Our ref: EOR0795

CML2111 – South Hook LNG Jetty Maintenance Activities

Thank you for your email. Following review please find below our response to NRW email **Sent:** 30 March 2021 08:45.

A.1 Attachment 1 – Maerl Bed Habitat Map and Barge Location

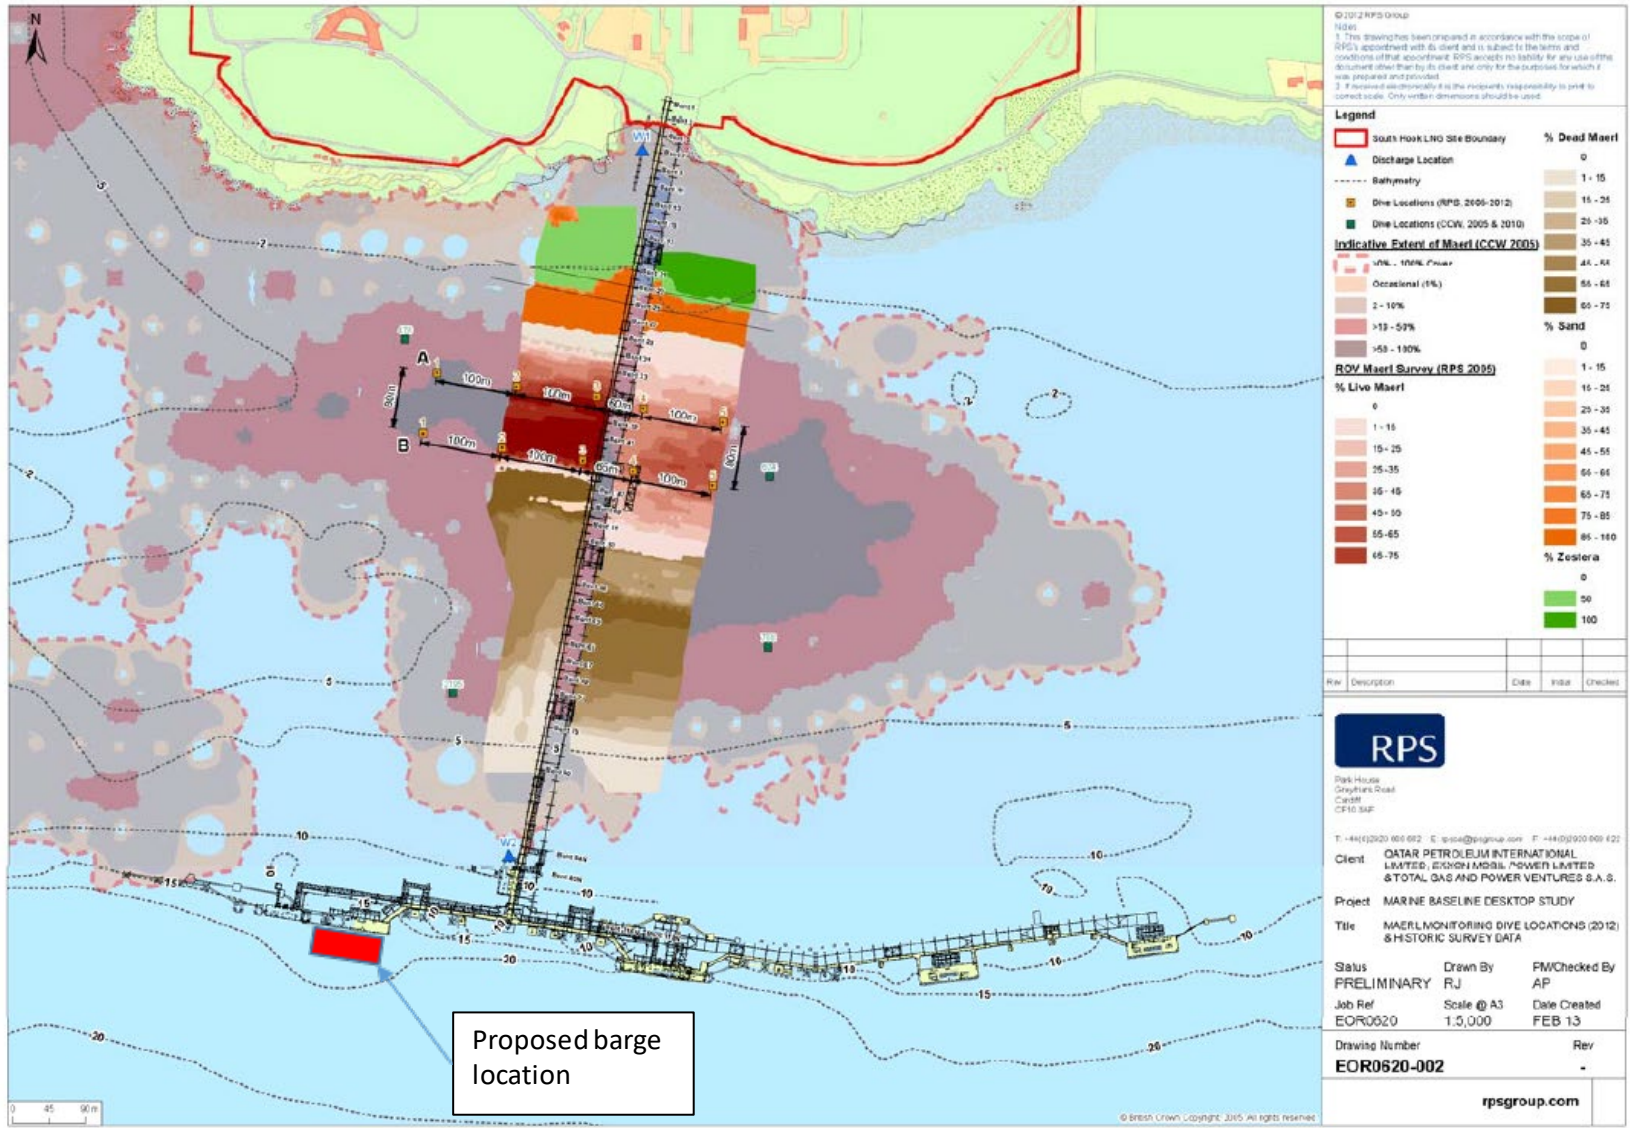
Maerl beds are considered sensitive to anthropogenic disturbance and have the potential to be impacted from activities that cause increases in suspended sediments and sediment deposition that may smother or cause impact on photosynthesis from reduction of light attenuation. Maerl beds have been found to exist approximately 200 m to the west and north of the barge location (attachment 1).

The deployment of each spud leg during loading arm retrieval and re installation will potentially displace/ disturb a maximum volume of 0.678 m³ per deployment (2.26 m² (Spud leg area) x 0.3 m (approximate penetration depth) of material. Even if sediments are disturbed, these will be disturbed locally, at the seabed and would be expected to fall out of suspension within close proximity (metres) of the location of spud leg placement. In the unlikely event that these sediments would be transported further afield the negligible volume of sediment disturbed (as outlined above) and the high dilution afforded within Milford Haven waterway would mean that suspended sediments would be below detectable levels in the immediate vicinity of the proposed works, with no adverse impacts on the Maerl Beds approximately 200 m to the west.

Given the negligible volume of sediments that will be disturbed, the immediate fall out of coarse sediments following suspension immediately following disturbance there will no impact on adjacent Maerl beds or any other benthic habitat within Milford Haven.
